RESPONSE TO REQUEST FOR ADDITIONAL INFORMATION

US-APWR Design Certification

Docket No.52-021

RAI NO.: NO. 750-5675 REVISION 2
SRP SECTION: 19 – Probabilistic Risk Assessment and Severe Accident Evaluation
APPLICATION SECTION: 19
DATE OF RAI ISSUE: 04/28/2011

Figure 19.513-1 Variation of Containment Pressure

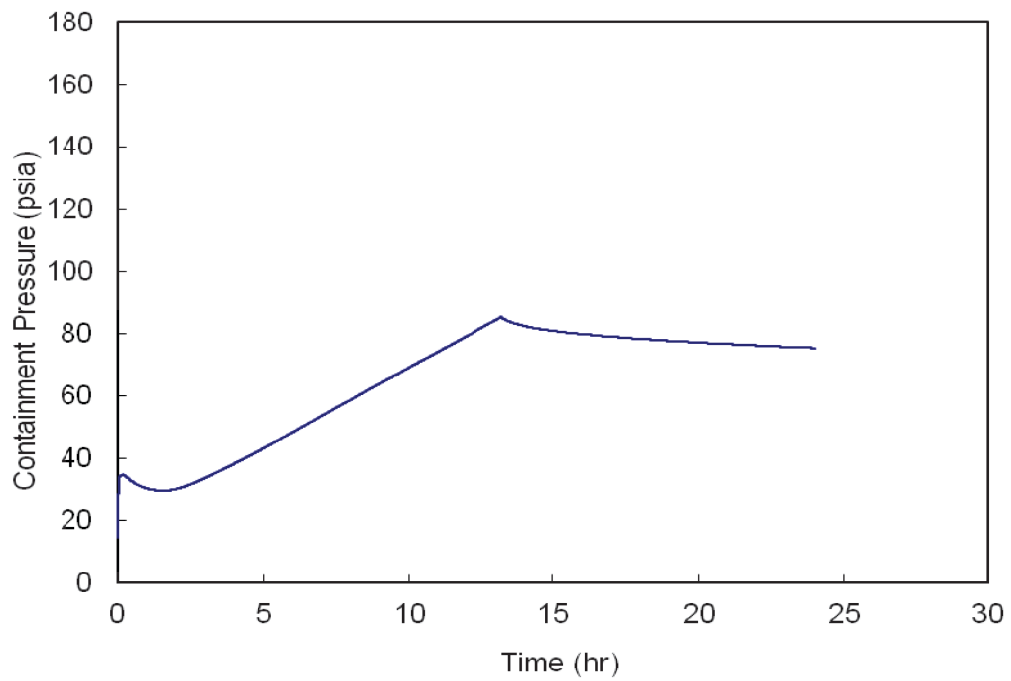
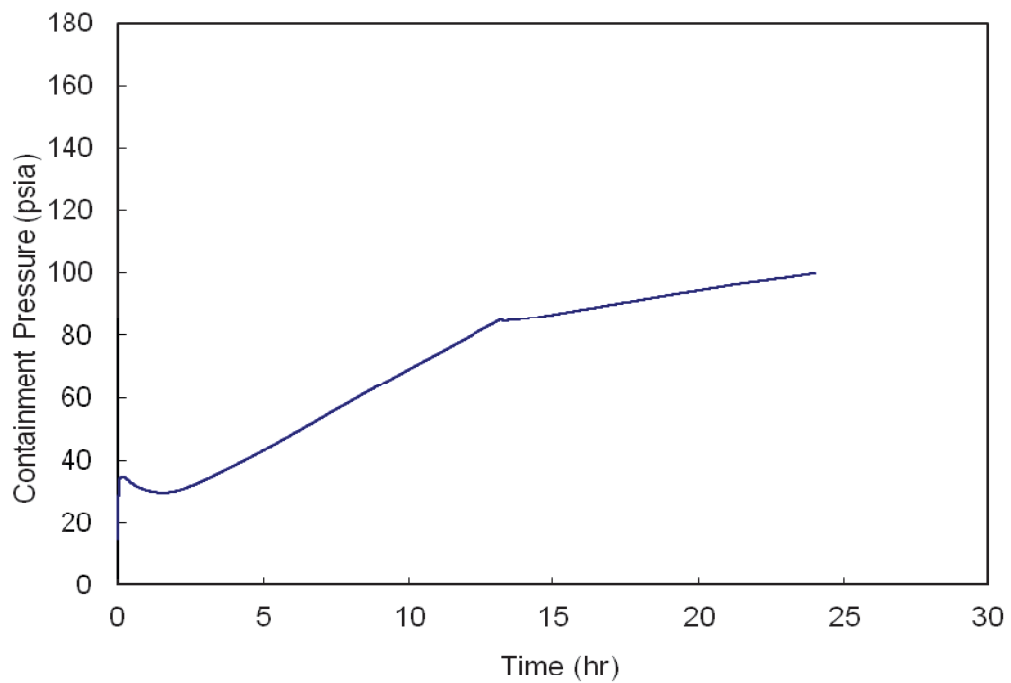
The success criterion used in the US-APWR PRA for alternate containment cooling using containment fan cooler units is one component cooling water (CCW) pump and two containment fan cooler units. To demonstrate that this success criterion maintains long-term containment integrity, MHI performed two MAAP analyses using the analysis conditions listed in Table 19.513-1. As shown in Figure 19.513-1 for Case 1 (two containment fan cooler units), containment pressure rises for 13 hours following the initiating event until reaching the containment design pressure. When the containment design pressure is reached, the alternate containment cooling is established, and the pressure subsides as long as heat removal via the containment fan cooler units remains available. In Case 2 (one containment fan cooler unit), containment pressure will continue to rise following the establishment of alternate decay heat removal using only one containment fan cooler. When the containment spray system using containment spray/residual heat removal (CS/RHR) pumps is available, the decay heat from the containment can be removed via the CS/RHR heat exchangers. However,

to operate alternate containment cooling with containment fan cooler units, the CS/RHR heat exchanger must be isolated from the CCW so that the alternate containment cooling does not degrade CCWS cooling to other CCWS loads. The US-APWR PRA assumes that failure to isolate the CS/RHR heat exchangers from the CCW system results in loss of the containment cooling function with the containment fan cooler units. Each containment fan cooler unit requires a CCW flow rate of approximately 100m³/hr (400 gpm). Each CCW pump is capable of supplying CCW with approximately 1,000m³/hr (4,000 gpm), thus one CCW pump has the capacity to supply sufficient cooling water to all four containment fan cooler units if the CS/RHR heat exchangers are isolated. Therefore, the success criterion of one CCW pump and two containment fan cooler units is appropriate for alternate containment cooling using containment fan cooler units. DCD Table 19.1-15 incorporating the MAAP analysis results was provided in the original response to this RAI (Ref: UAP-HF-11201, dated June 30, 2011). (The US-APWR PRA model does not need to be revised to reflect the discussion.)

Figure 19.513-2 Maximum Temperature of Fuel Clad (Sheet 1 of 2)

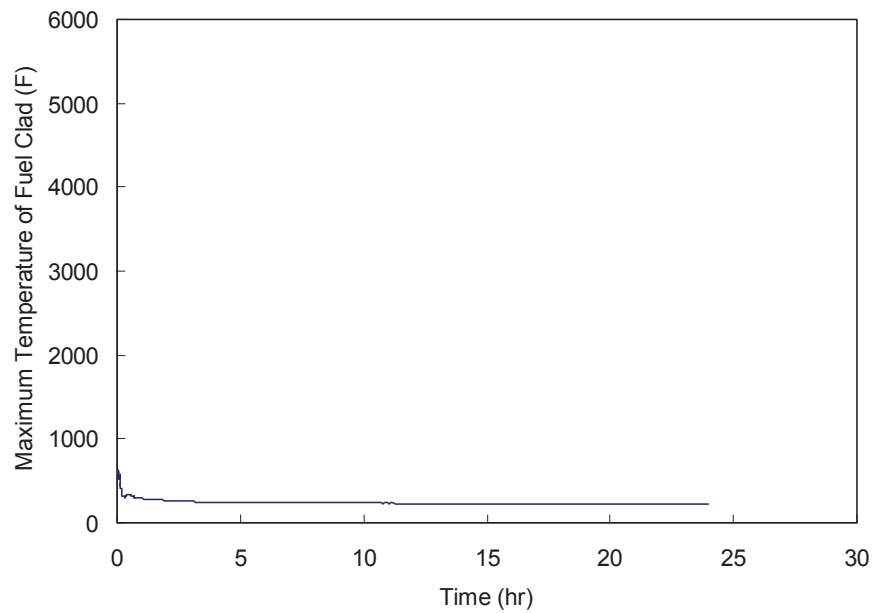
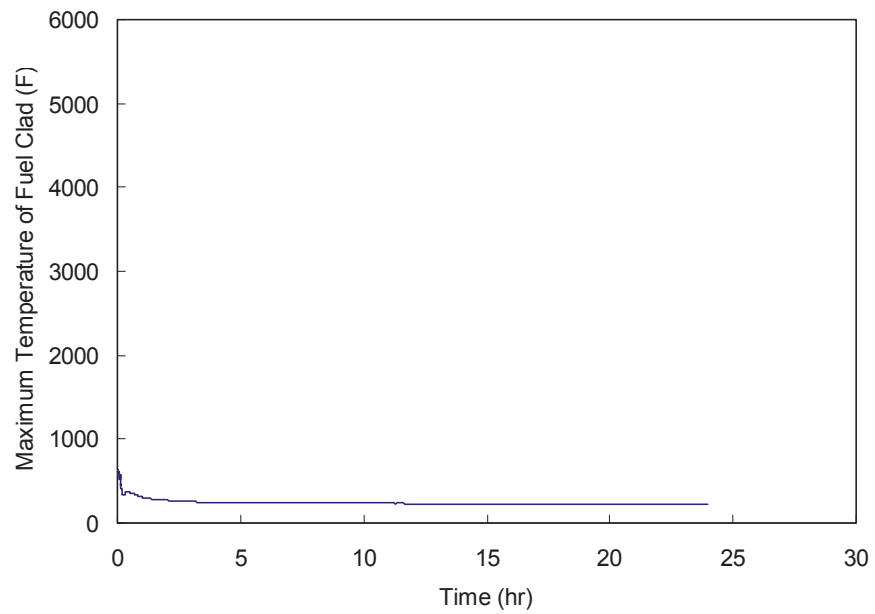
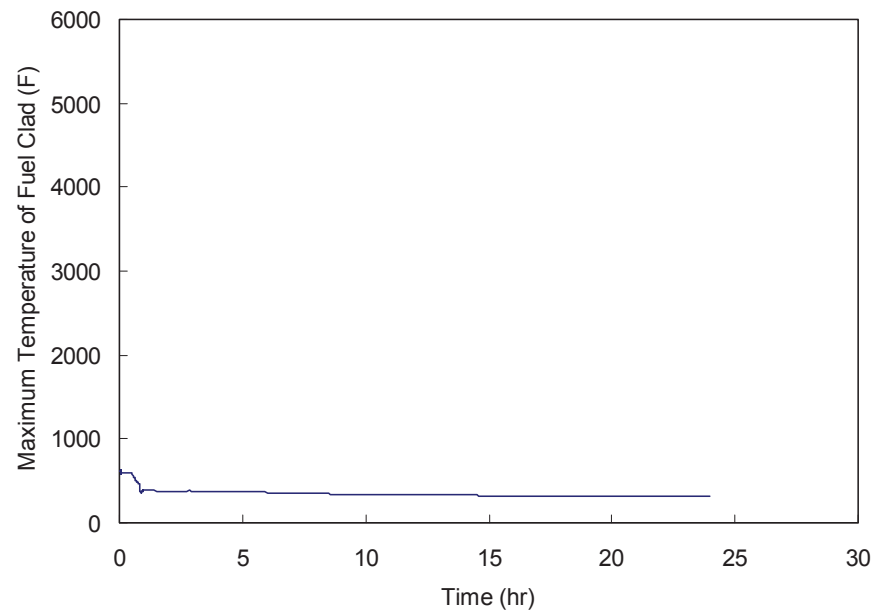
Three T-H analyses were performed to investigate the capacity of alternate core cooling using CS/RHR pumps and heat exchangers. Table 19.513-2 provides the system conditions and the peak cladding temperature (PCT); Figure 19.513-2 shows the maximum fuel cladding temperature as a function of time. The cases depict two break sizes. Cases 1 and 2 differ only in the assumed time for the start of core cooling. For all cases, it was determined that PCT is much less than 1400°F, which is the MAAP criterion for core damage, and that three EFW pumps and three MSDVs are sufficient to prevent core damage, thus affirming the DCD Table 19.1-16 success criteria of three EFW pumps and three MSDVs for alternate core cooling using CS/RHR pumps.

The T-H analysis results do not affect the current PRA model. DCD Table 19.1-15 Item No. 1.5 will be revised, as shown in the attached markups.

Figure 19.513-3 Containment Pressure

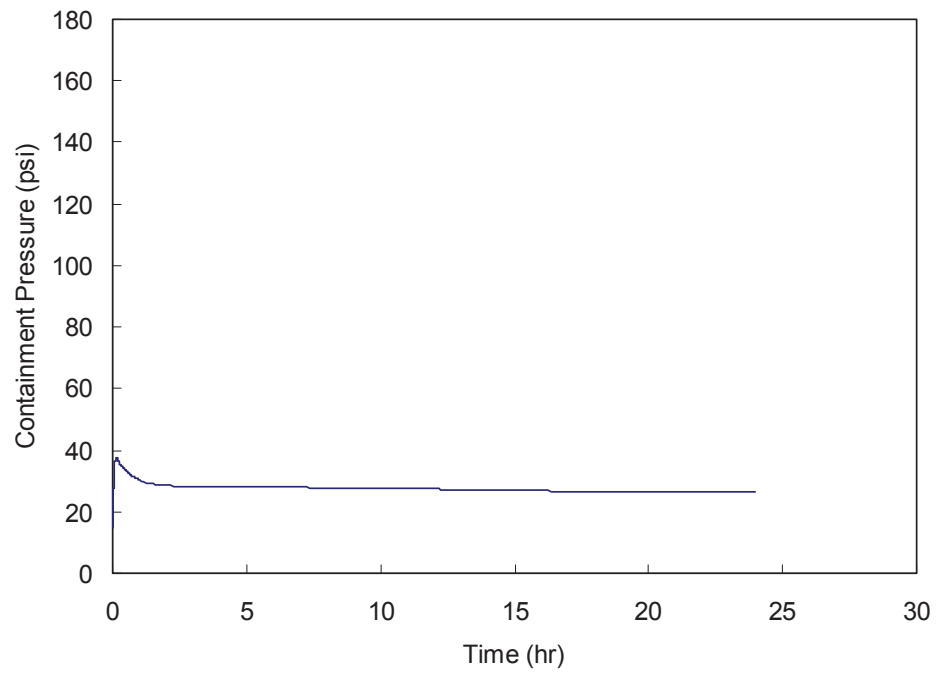
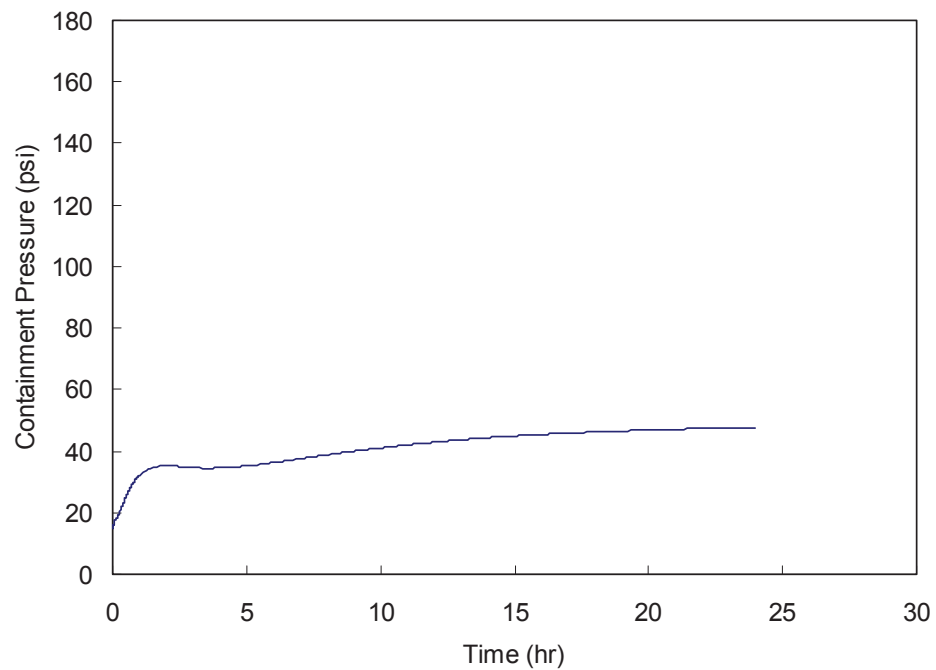
Two additional T-H analyses were conducted to investigate the alternate containment cooling function using CS/RHR pumps. Table 19.513-3 provides the system conditions and the maximum containment pressure; Figure 19.513-3 illustrates containment pressure versus time. For both cases, containment pressure within 24 hours after the initiating event did not exceed the containment design pressure (216 psia). Therefore, MHI concludes that containment integrity could be maintained using one CS/RHR pump and heat exchanger with three EFW pumps and three MSDVs.

The T-H analysis results do not impact the PRA model. DCD Table 19.1-15 Item No. 2.3 will be revised, as shown in attached markups.

Figure 19.513-4 Analysis Results of Sequence followed by Isolation Failure of Ruptured SG (Sheet 1 of 2)

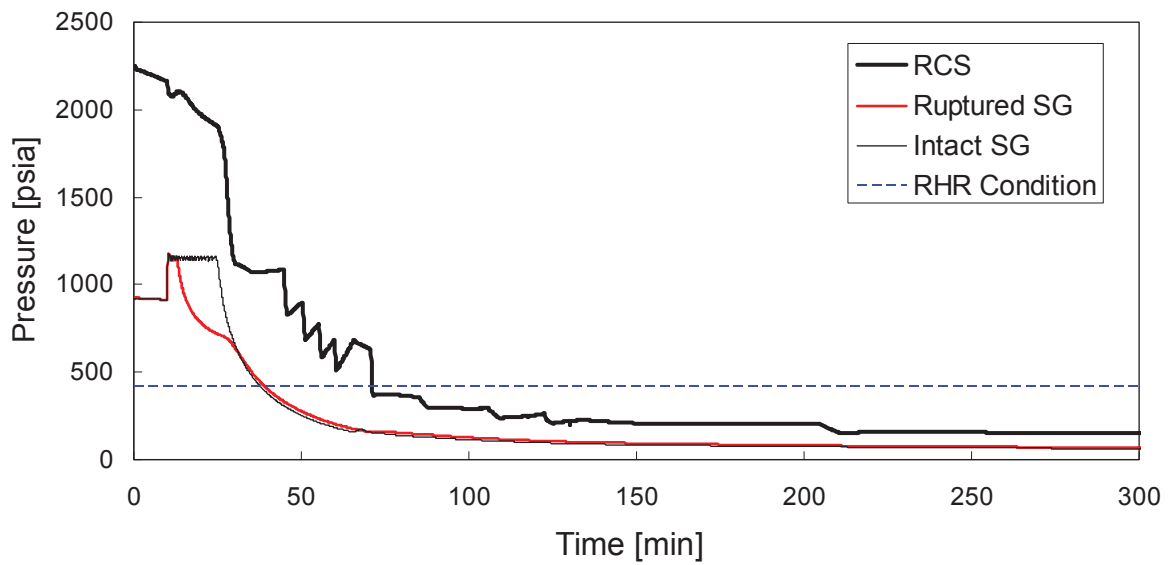
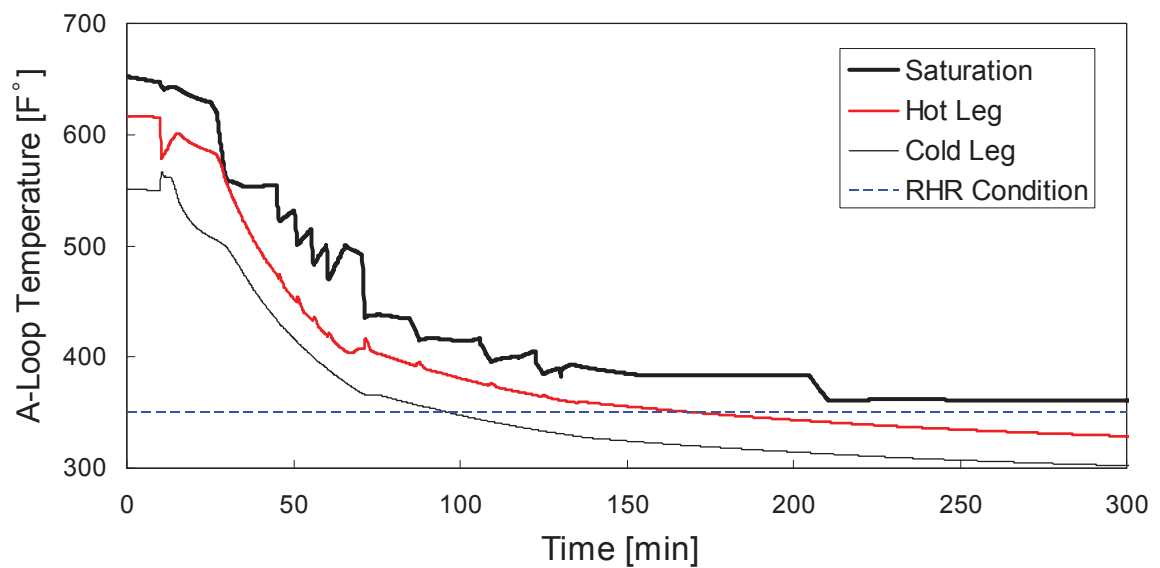
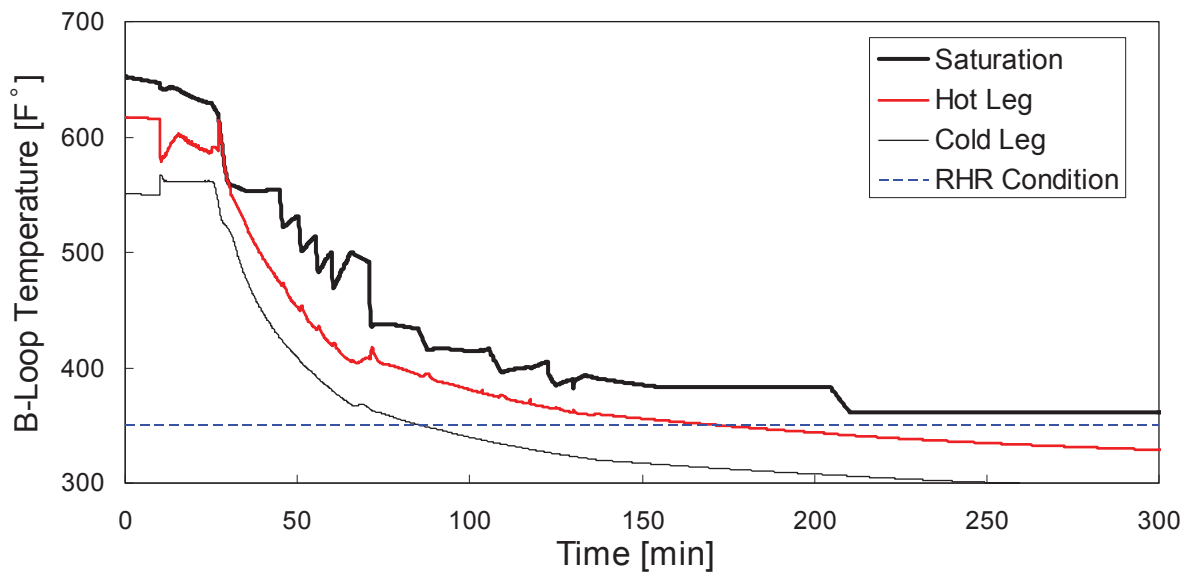
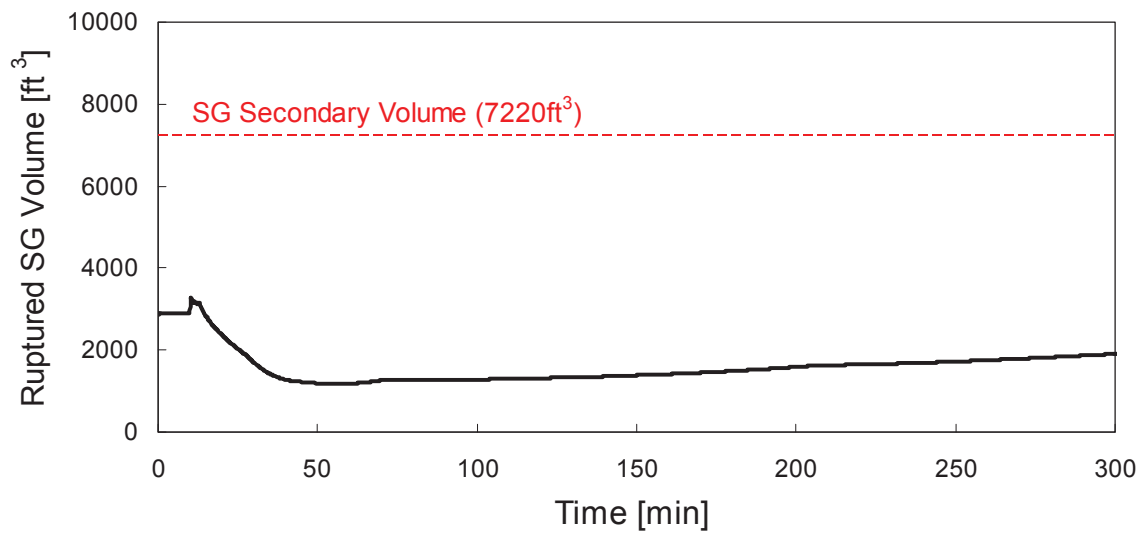
Table 19.513-5 and Figure 19.513-4 show the time sequence and time variation of typical system behavior for these sequences, respectively. Approximately 75 minutes after the initiating event, the RCS is depressurized sufficiently to permit RHR operation. But, the RCS temperature still exceeds the RHR operation condition (i.e., greater than 350°F). Operators manually open at least one SDV to reduce the RCS temperature, establishing RHR operation at approximately 173 minutes. After that, long-term decay heat removal

can be achieved by one CS/RHR pump and heat exchanger. As depicted in Figures 19.513-4 (2) and (3), the RCS temperature of each loop is below the saturation temperature indicating that no boiling will occur in the RCS. Also note that, as shown in Figure 19.513-4 (4), there is no SG overfill. After that, the RCS is depressurized to atmospheric conditions by RHR operation in order to terminate the leakage via the ruptured tube, maintaining RCS makeup using charging injection.

From the above, it is reasonable to assume that the aforementioned configuration is sufficient to prevent core damage. The success criteria in the PRA will be updated to be consistent with the MARVEL-M analysis conditions listed in Table 19.513-4. DCD Table 19.1-15 Item No. 3.5 will be added, as shown in attached markups. The model change does not affect PRA results and PRA insights such as the dominant core damage scenarios, importance measures, or uncertainty analyses results. This is because the dominant cutset consists of a combination of human errors, considering their dependency, rather than a combination of component failures.

**Figure 19.513-5 Analysis Results of Sequence with No Core Injection Function
(Sheet 1 of 2)**

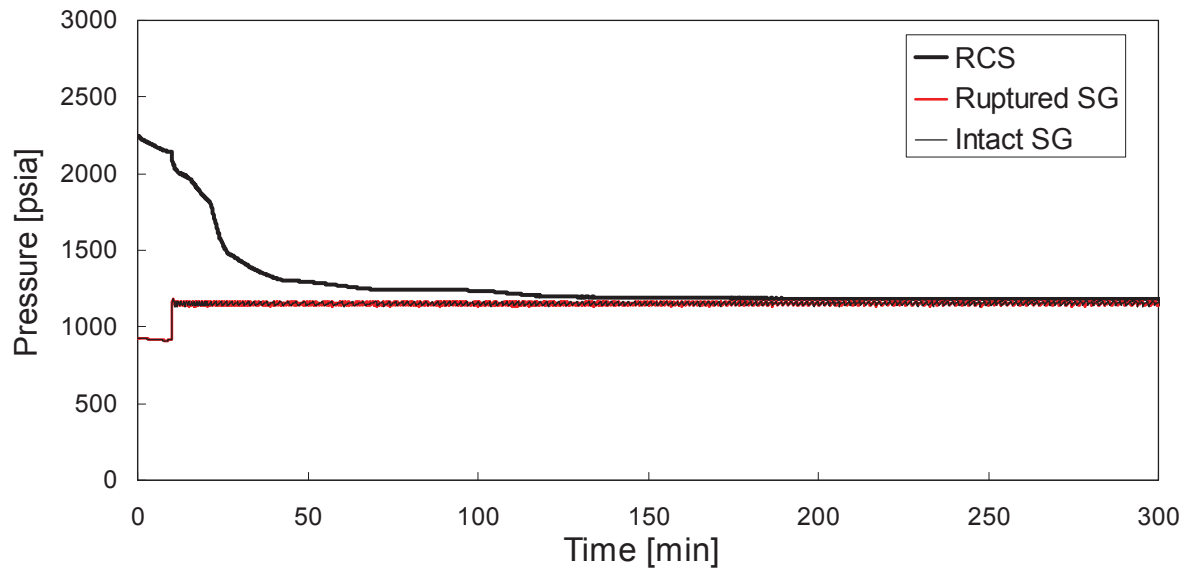
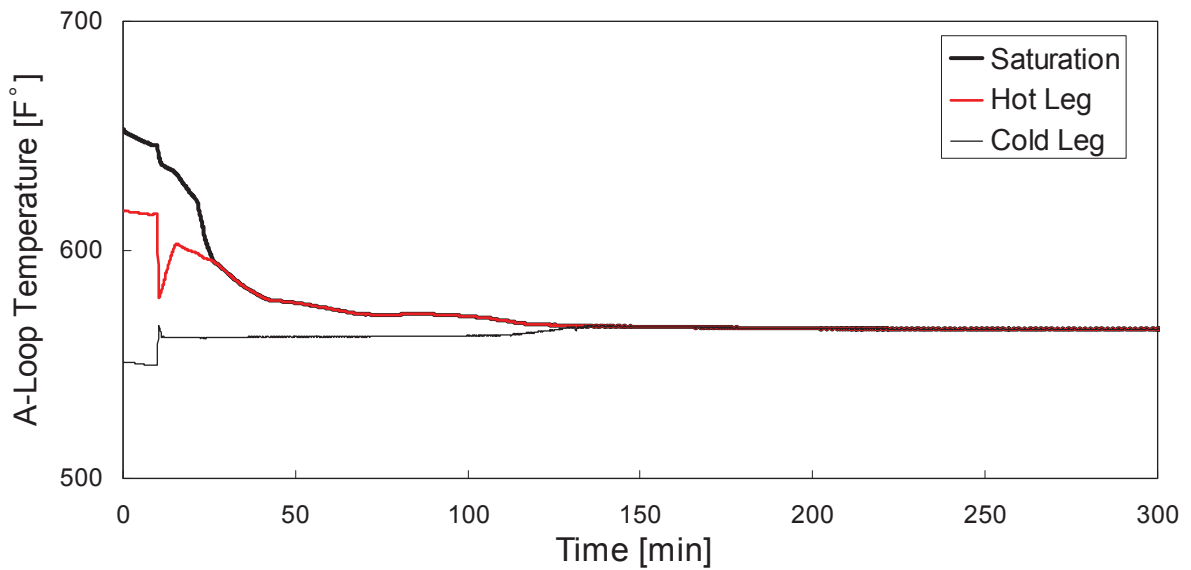
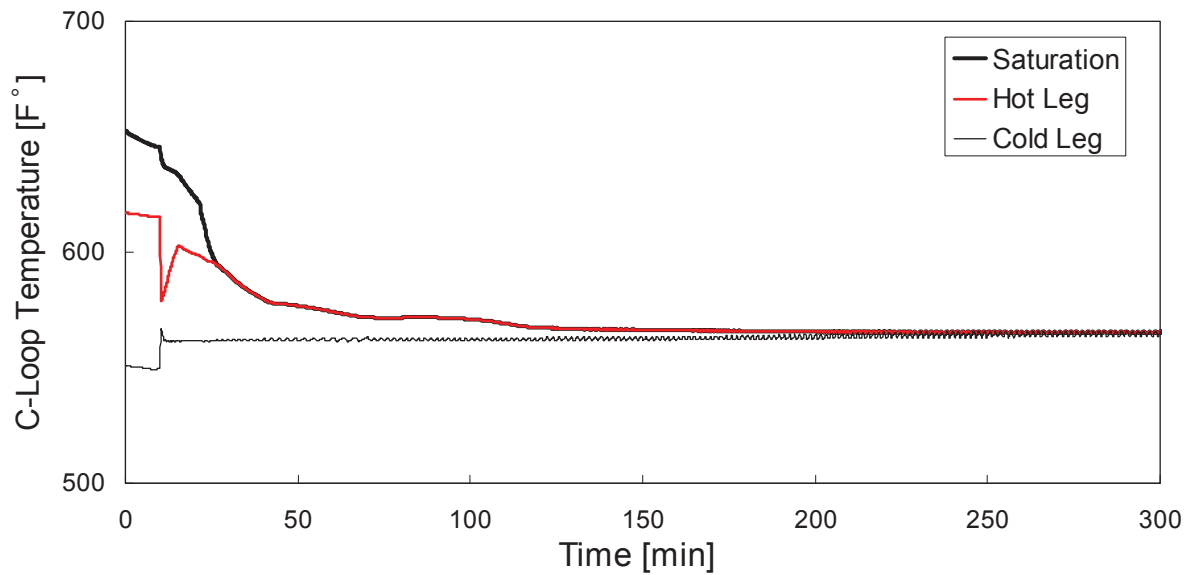
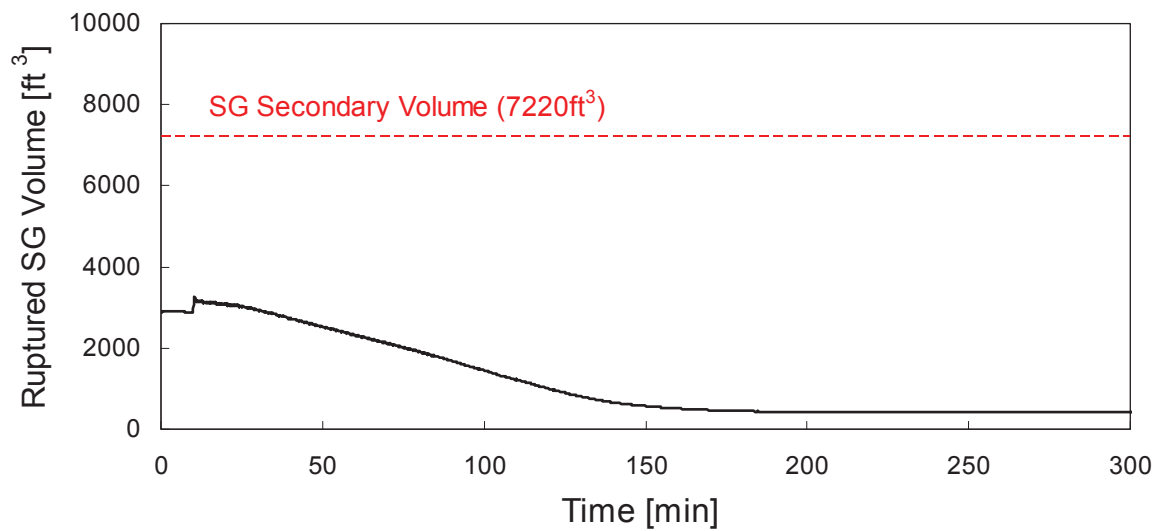
This RAI response provides the MARVEL-M thermal-hydraulic analysis results for Sequence #20 in DCD Figure 19.1-1 sheet 5, based on analysis conditions in Table 19.513-6. Table 19.513-7 and Figure 19.513-5 show the time progression for this scenario and time variation of typical parameters, respectively. In this scenario, the RCS was depressurized using decay heat removal with two SGs available with flow from one EFW pump, and no SI pumps. As depressurization proceeds, the pressure difference between the RCS and secondary side system gradually becomes less, resulting in a decreasing leak rate through the ruptured SG tube to within the capability of the charging system.
